ATTACHMENT A
ODCM, Revision 25

SUBJECT: UNITS 2/3 OFFSITE DOSE CALCULATION MANUAL Revision 25

Enclosed is Revision 25 to the Units 2/3 Offsite Dose Calculation Manual (ODCM). This revision added steam generator blowdown and the Full Flow Condensate Polisher Demineralizer (FFCPD) holdup tank (HUT) as liquid release points and revised the Turbine Plant Sump discharge flowrates to reflect the replacement of the pump per DCP 2-6747. In recognition of unequal mixing in the plant vent stack, minimum instrument requirements for noble gases were revised to require both radiation monitors on the unit-specific branches whenever the radiation monitor on the common plenum is out of service. Additionally, radiation monitor calibration constants were updated to reflect recent surveillances and there was one editorial change for typographical errors. This revision also encompasses the update of tables used in liquid and gaseous dose calculations that resulted specifically from the 1991 Land Use Census. None of the changes result in any modifications to either the plant configuration or operation. As such, there is no impact on the accuracy or reliability of methods for determining effluent dose

FIGURE 4-5 SONGS 2 & 3 RADIOACTIVE LIQUID WASTE TREATMENT SYSTEMS

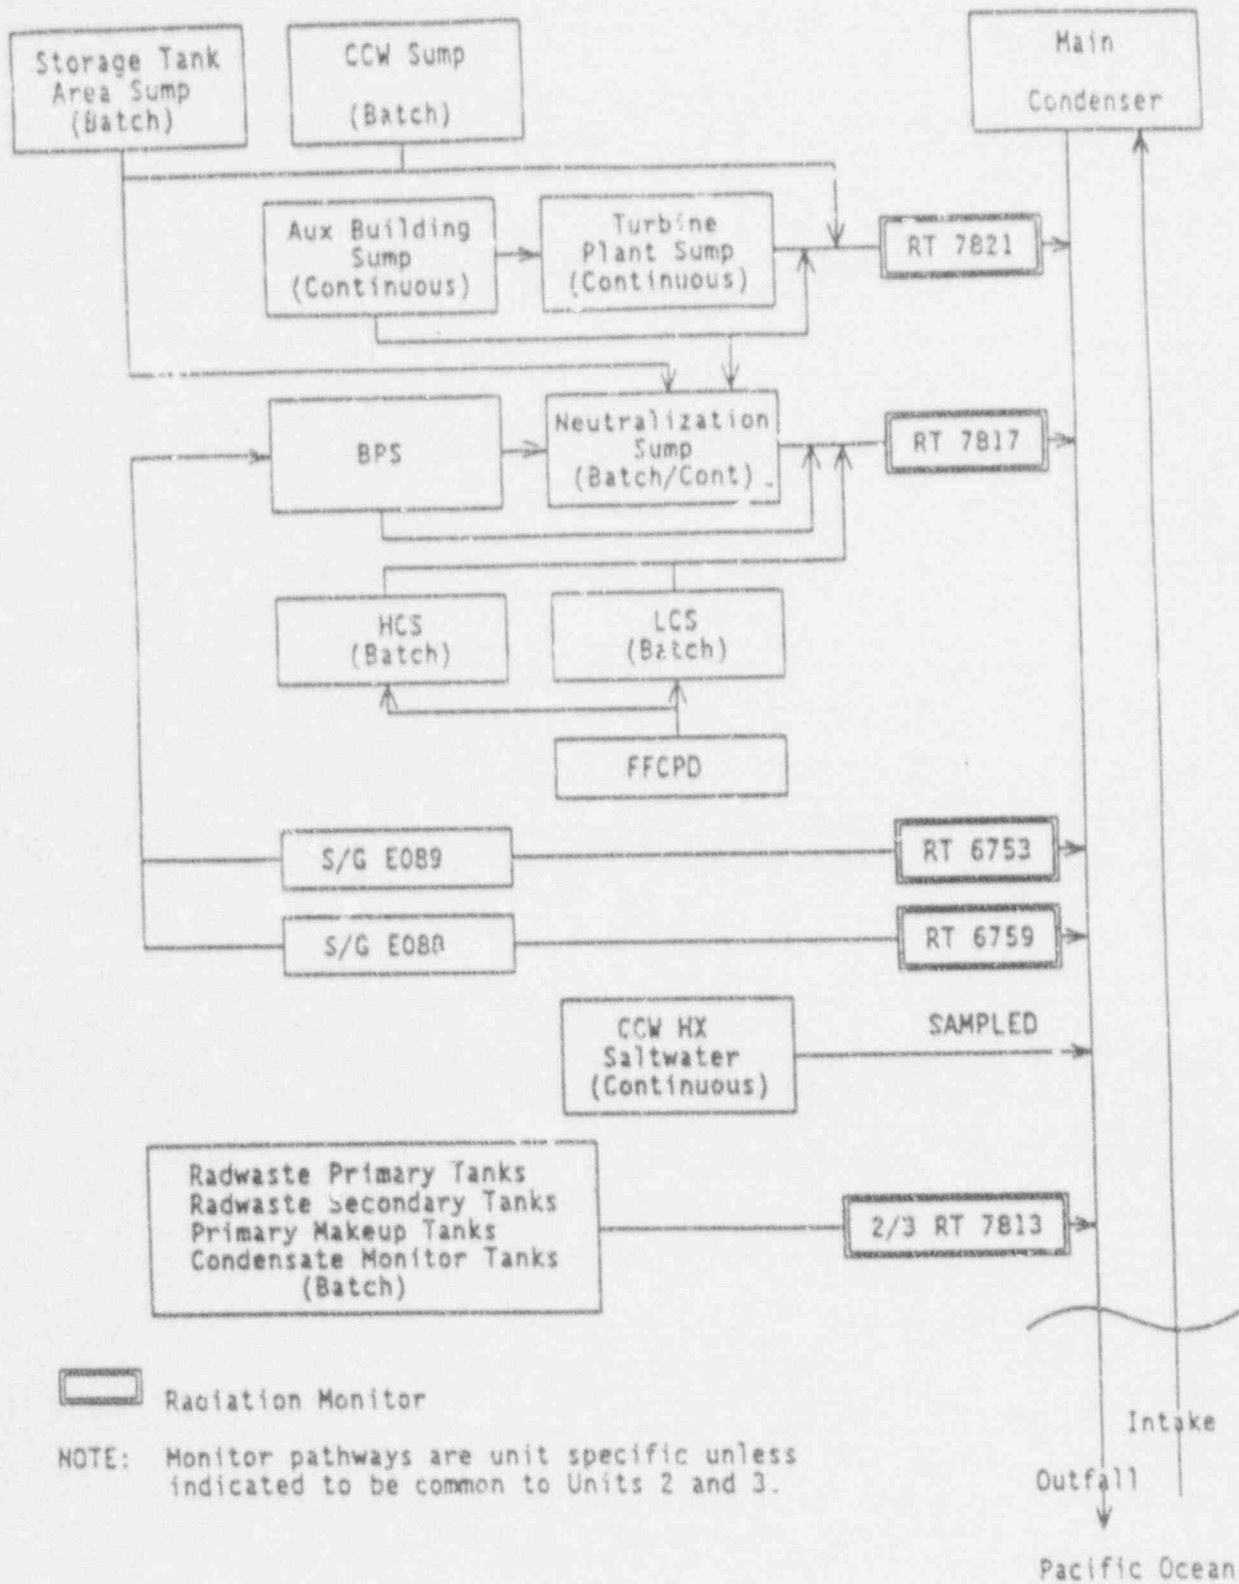
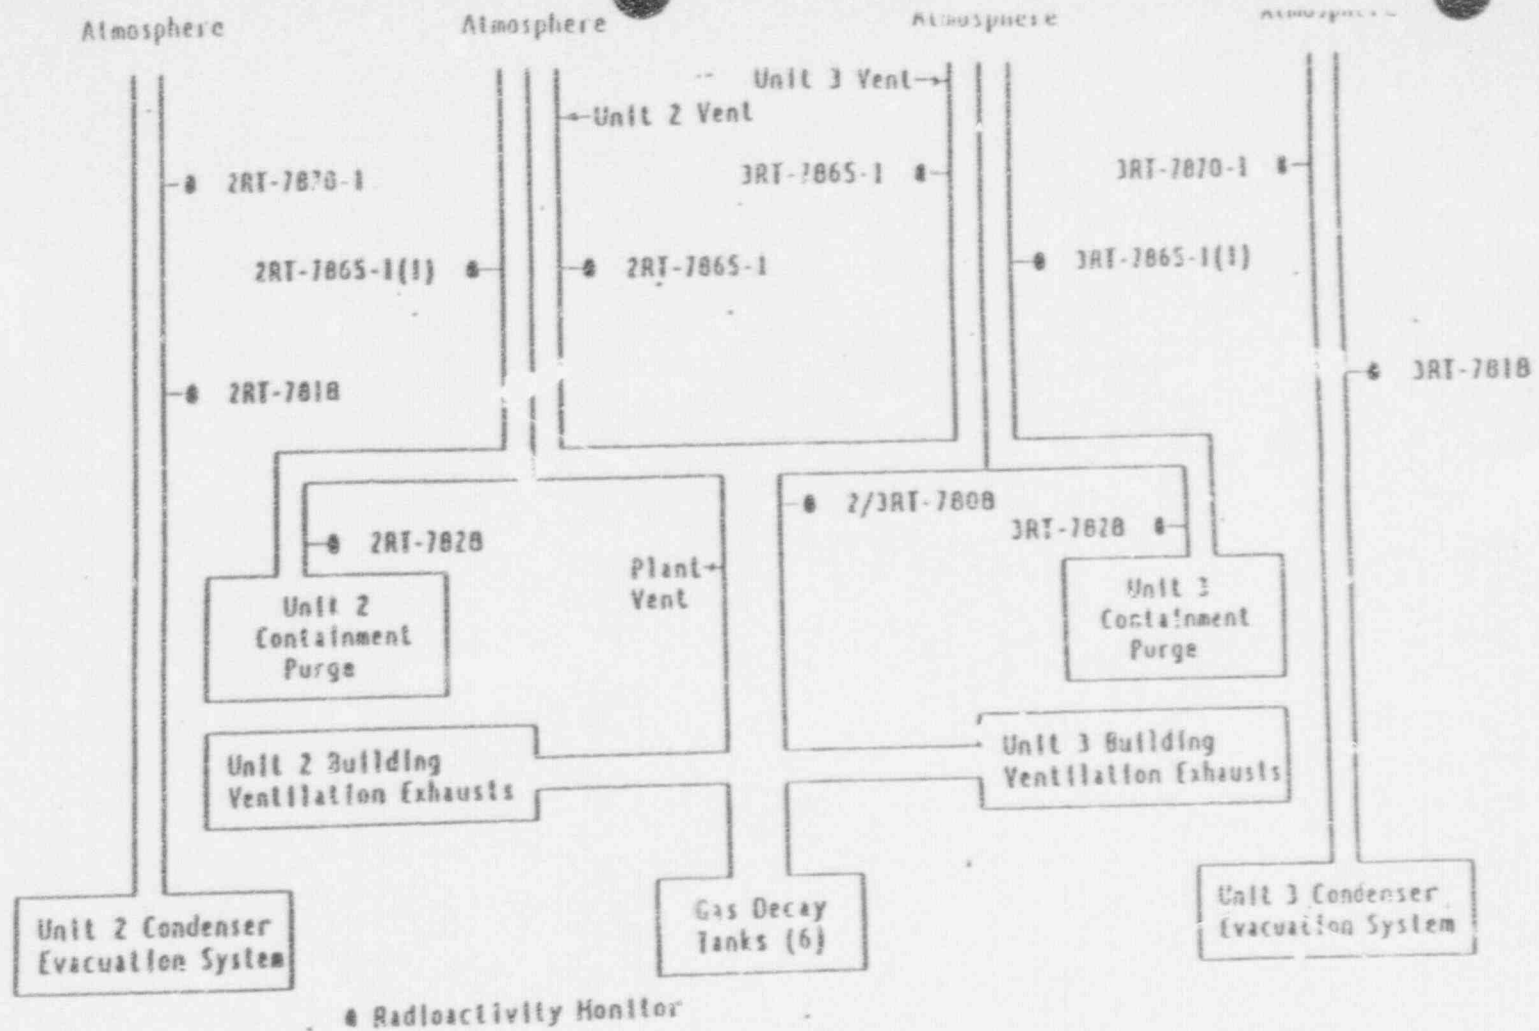
- 1-2 Added SG Blowdown and FFCDP HUT as liquid batch release points
- 1-15 Added discharge value for FFCDP Holdup Tank
- 1-23 Added separate discharge flowrate value for Unit 2 per DCP 2-6747

- 2-80* Reformatted definitions
- 2-81* Reformatted definitions
- 2-82* Reformatted definitions
- 4-2* Table 4-1, to 1.c, added Auxiliary Building Sump, Component Cooling Water Sumps, and Storage Tank Area Sumps

FIGURE 4-6 SONGS 2 & 3 RADIOACTIVE GASEOUS WASTE TREATMENT SYSTEMS

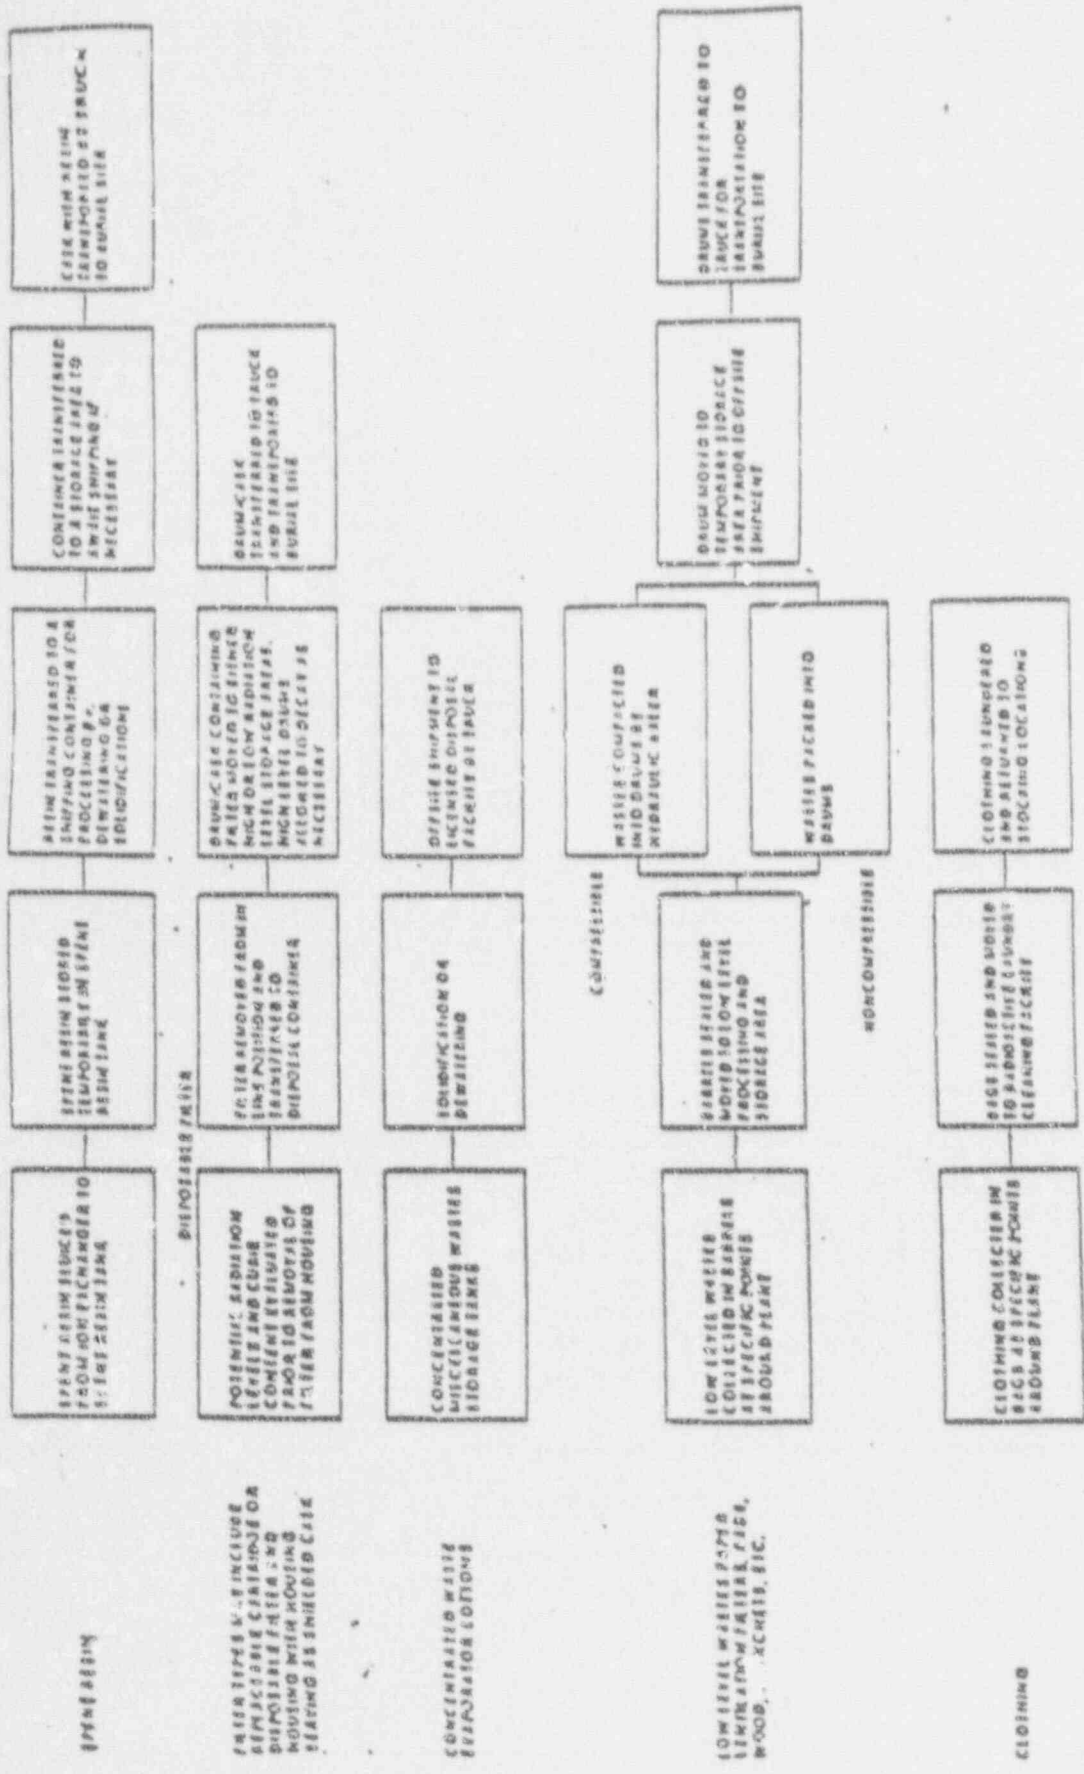
- 4-7 Modified noble gas monitoring requirement for plant vent stack to require both RT-7865s when 2/3RT-7808 is inoperable
- 4-8 Modified footnote (2) to require process flow verification on the plant vent stack if either RT7865 is not available. Added footnote (3).

(1) RT-7865 can be aligned to either containment purge or the plant vent stack
